UNITED STATES PATENT AND TRADEMARK OFFICE

APPLICATION NO.	FILING DATE	FIRST NAMED INVENTOR	ATTORNEY DOCKET NO.	CONFIRMATION NO.
10/767,716	01/30/2004	Shunichi Kunihiro	00862.023436	6056
5514	7590	06/13/2006		
FITZPATRICK CELLA HARPER & SCINTO 30 ROCKEFELLER PLAZA NEW YORK, NY 10112			EXAMINER UHLENHAK, JASON S	
			ART UNIT 2853	PAPER NUMBER

Office Action Summary	Application No.	Applicant(s)	
	10/767,716	KUNIHIRO, SHUNICHI	
	Examiner	Art Unit	
	Jason Uhlenhake	2853

DETAILED ACTION

Fig. 10

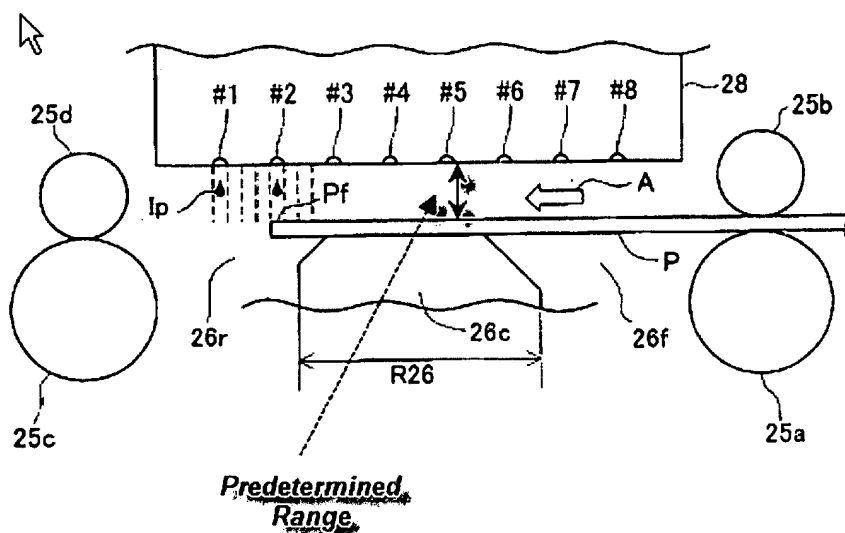
Independent claims 1, 7 and 8 are rejected regarding Otsuki et al. Otsuki et al discloses a printing medium held by one of a first and second conveying means (Figures 10, 14) and describes specific nozzles used (setting or selecting) for “upper edge routines” and “lower edge routines” (Column 12, Lines 16 – 37), also discloses a

distance between the discharge surface of each nozzle and the printing surface of the printing medium falls within a predetermined range (Figure 10).
